**KNOXVILLE/KNOX COUNTY METROPOLITAN PLANNING COMMISSION
 SUBDIVISION REPORT - CONCEPT/USE ON REVIEW**

▶ **FILE #:** 10-SB-15-C **AGENDA ITEM #:** 11
 10-B-15-UR **AGENDA DATE:** 10/8/2015

▶ **SUBDIVISION:** HAMILTON FARM
 ▶ **APPLICANT/DEVELOPER:** RICK WILKINSON
 OWNER(S): Rick Wilkinson

**10-SB-15-C / 10-B-15-UR
CONCEPT PLAN/USE ON REVIEW**

Concept Plan
 SHEET NO:
C-1.0

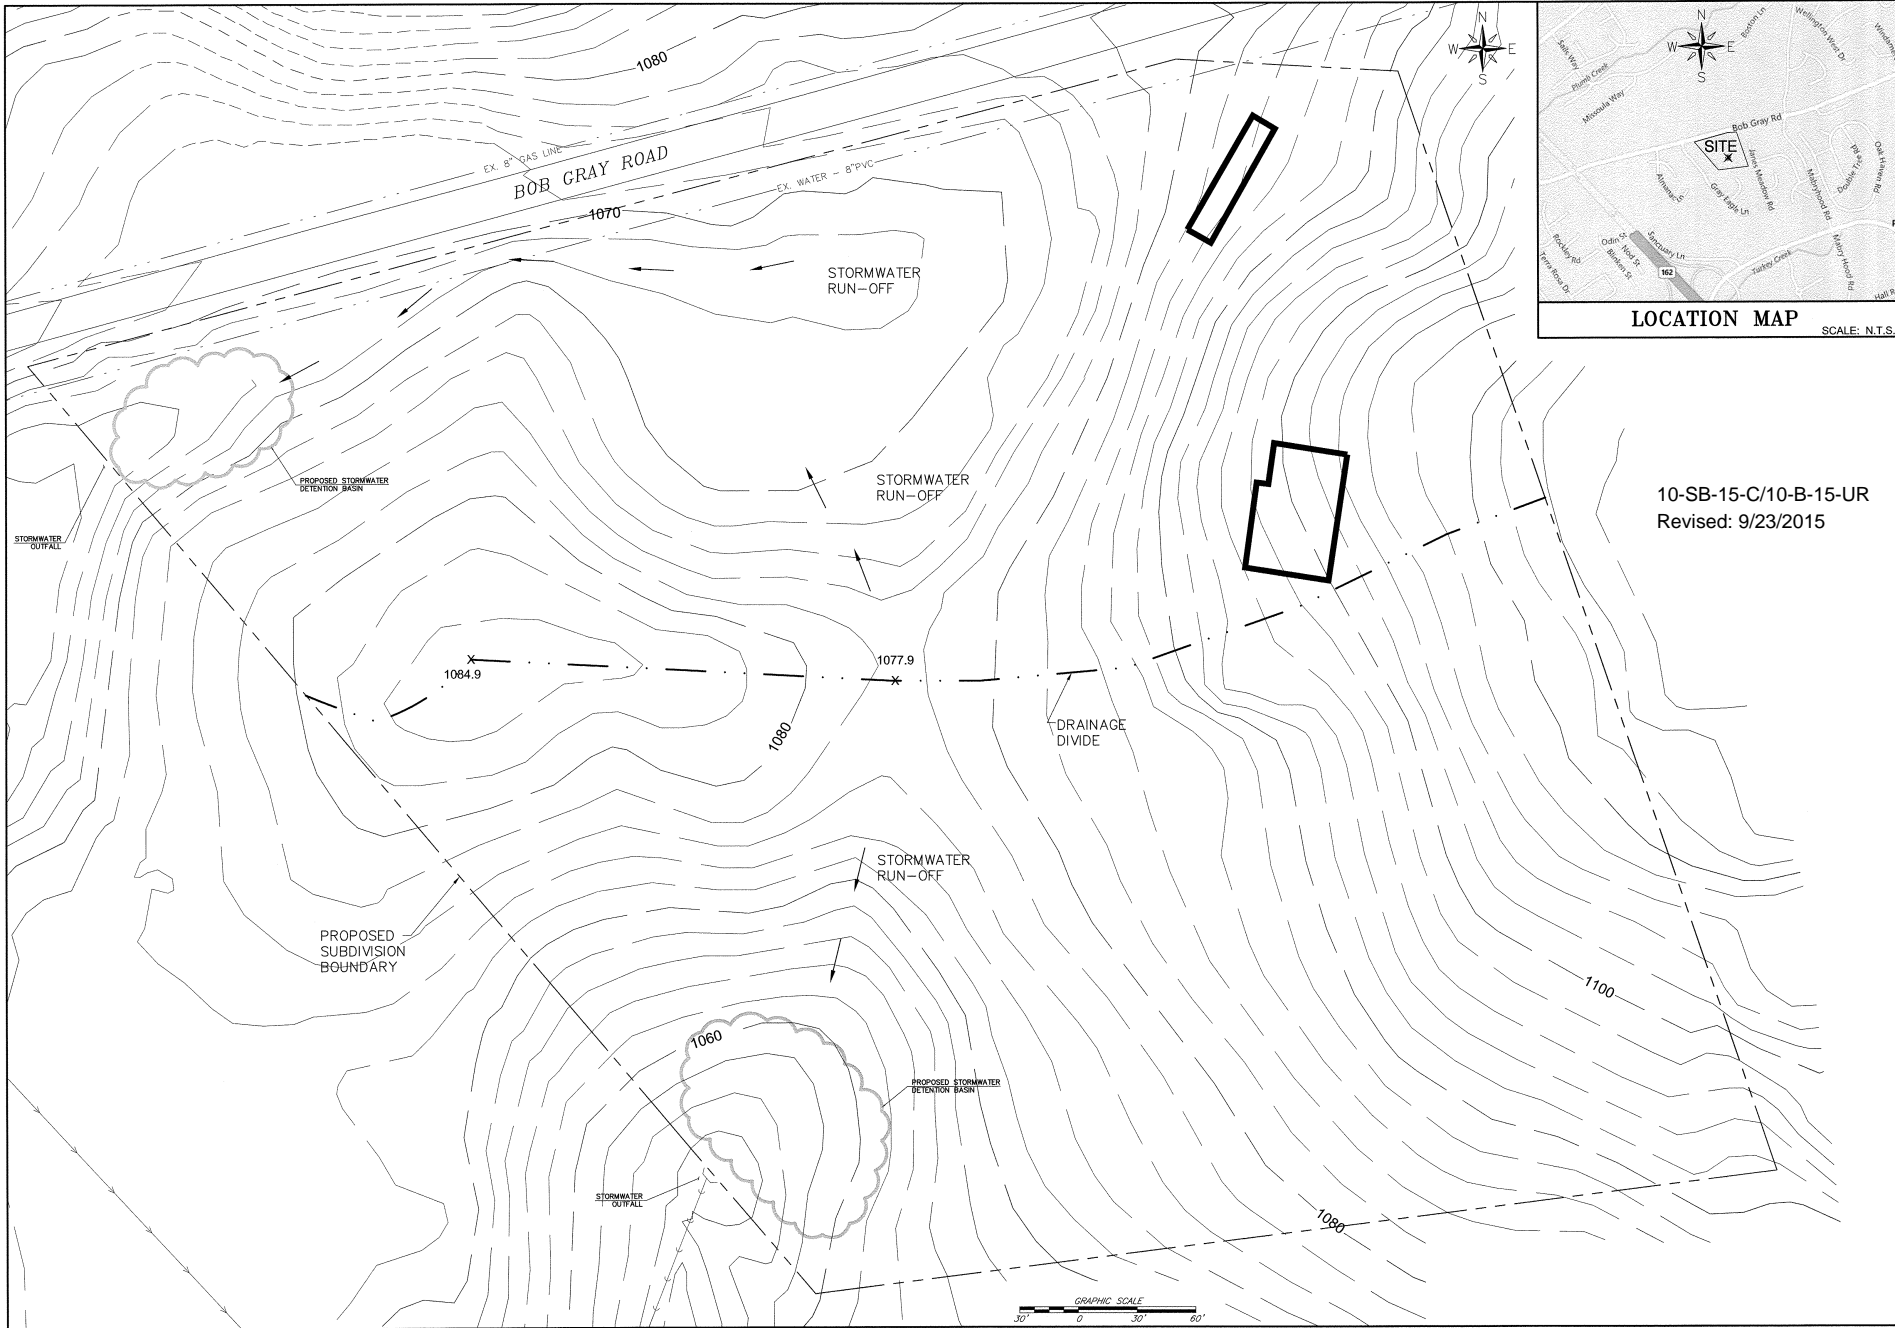
1. Horizontal curve radius variance on Hamilton Farm Rd. from 250' to 100' between STA 0+28.71 and STA 0+72.58.
2. Horizontal curve radius variance on Hamilton Farm Rd. from 250' to 100' between STA 4+52.46 and STA 5+49.88.
3. Horizontal curve radius variance on Hamilton Farm Rd. from 250' to 120' between STA 6+24.54 and STA 8+84.63.
4. Broken back tangent variance on Hamilton Farm Rd. from 150' to 74.66' between STA 5+49.88 and STA 6+24.54.

4. Including sight distance easements across Lots 26 and 27 on the final plat.
5. Prior to obtaining a design plan approval for the subdivision, submitting a detailed grading plan to the Knox County Department of Engineering and Public Works and Planning Commission Staff that documents all proposed lots will have adequate building sites and yard areas with driveway grades not exceeding a 15% grade. Those lots that cannot comply with this condition will have to be combined with adjoining lots on any final plats submitted to the Planning Commission for approval.

The preliminary grading and stormwater plan identified a potential problem with having adequate building sites on approximately five lots within the subdivision. Staff has recommended a condition that the applicant provide a detailed grading prior to design plan approval that documents that adequate building sites are available on all proposed lots.

▶ **APPROVE** variances 1-4 because the site's topography and shape restrict compliance with the Subdivision Regulations and the proposed variances will not create a traffic hazard.

APPROVE the Concept Plan subject to 8 conditions
